DOCUMENT NO: OP-1903.004

TITLE: ADMIN. & MAINTENANCE OF THE
EMERGENCY PLAN & IMPLEMENTING
PROCEDURES

REVISION NO: 022-03-0

ENTERGY OPERATIONS INCORPORATED
ARKANSAS NUCLEAR ONE

ATTACHMENT 1

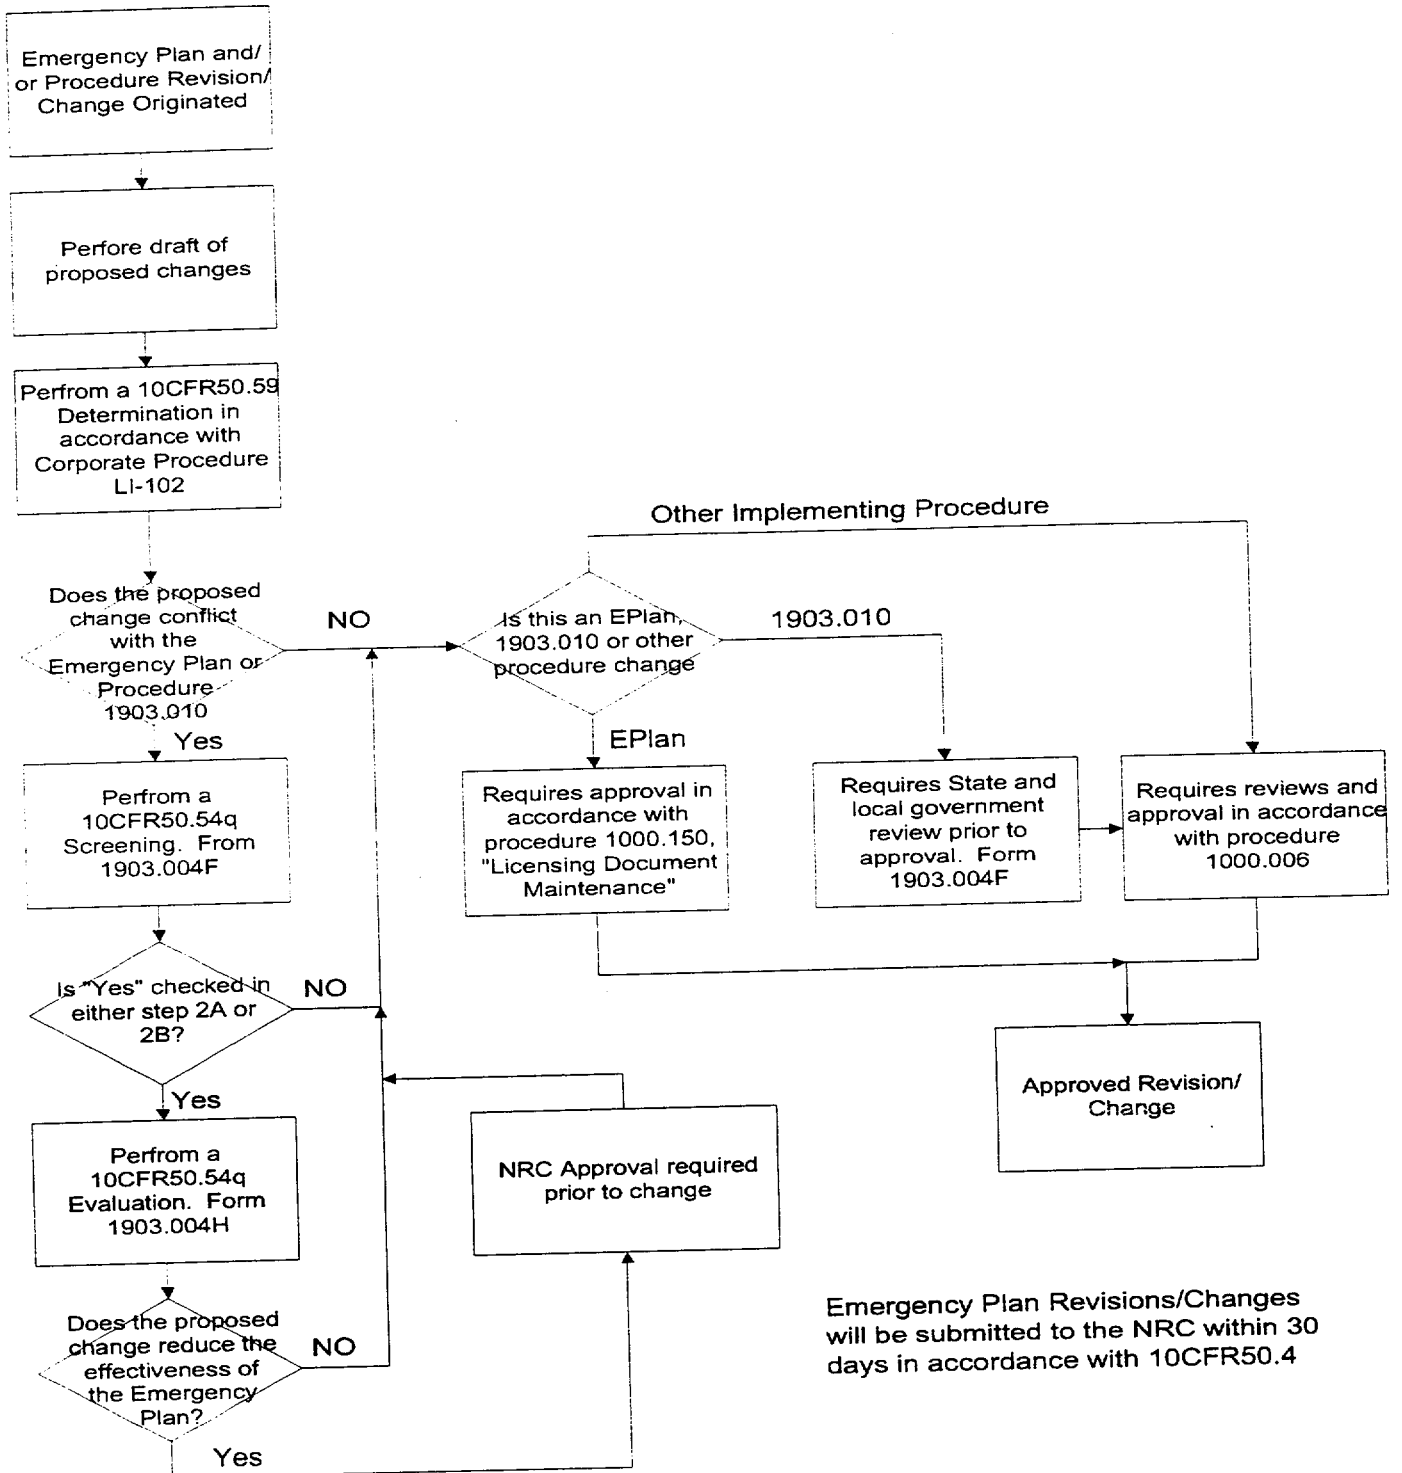
Deleted old chart and added new chart.
